7TH AUGUST 1889, No. 2122 W., PUBLIC WORKS.

Water-supply of the Lawrence
Asylum, Ootacamund

Describing the kind of stand pipe re-
quired for the —.

FIG. 59.E.

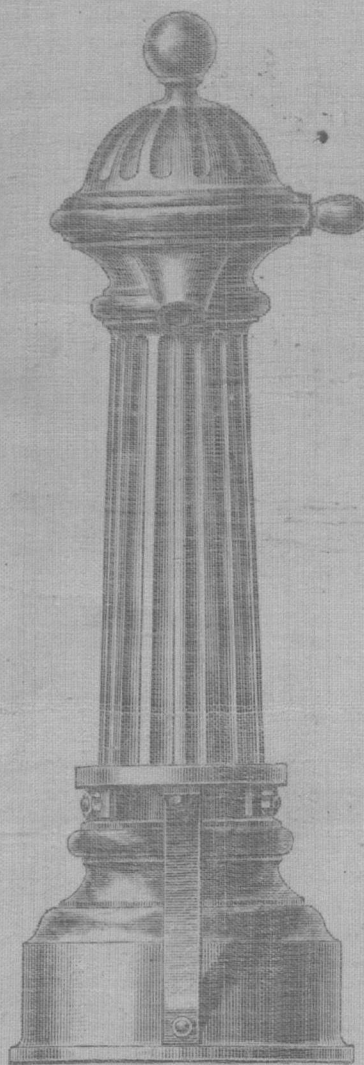
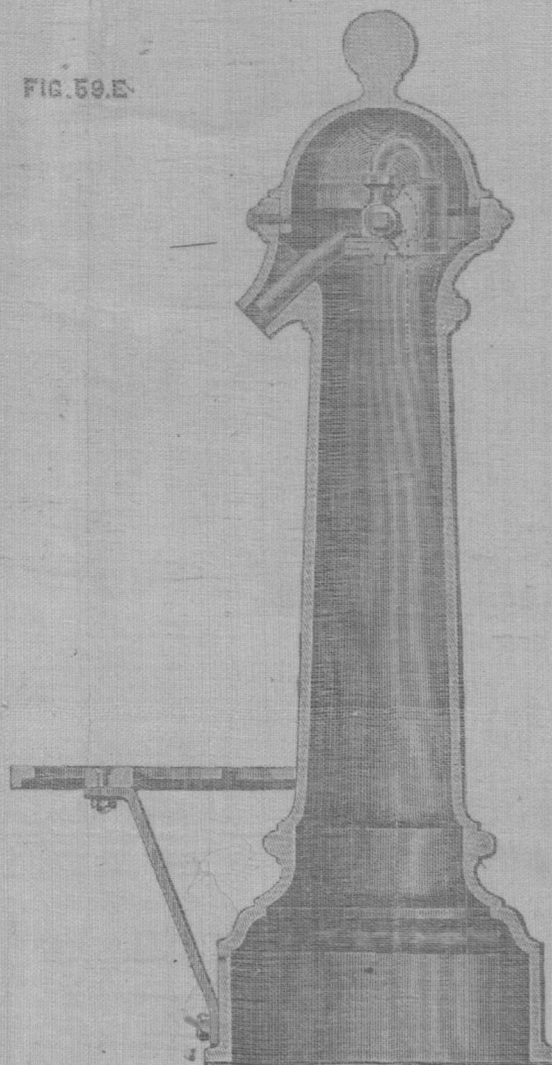
With reference to your endorsement No. 587 D., dated 25th July 1889, I have the honor to return the accompanying design with the documents received, and to inform you that Fig. No. 59 E is practically the same as Kennedy's patent self-closing fountains, with the exception of the base flange, which in Guest and Chrimes' sketch is too narrow to be bolted to the masonry platform.

With reference to your endorsement No.
587 D, dated 25th July 1889, I have the honor to return
the accompanying design with the documents received
and to inform you that Figure No. 59 E. is practically
the same as Kennedy's patent self-closing fountain
with the exception of the base flange which in Lysart
and Lebrunes sketch is too narrow to be bolted to the
masonry platform.

I would request that the lower base flange
be made similar to the sketch herewith enclosed, so as
to allow the fountain being bolted to a masonry bed.

to be bolted to the masonry
platform - It is requested
that the lower base flange
be made in accordance with
the sketch herewith enclosed,
signed by Col Ross Thompson,
Executive Engineer, so as to allow
of the fountain being bolted to
the masonry bed -
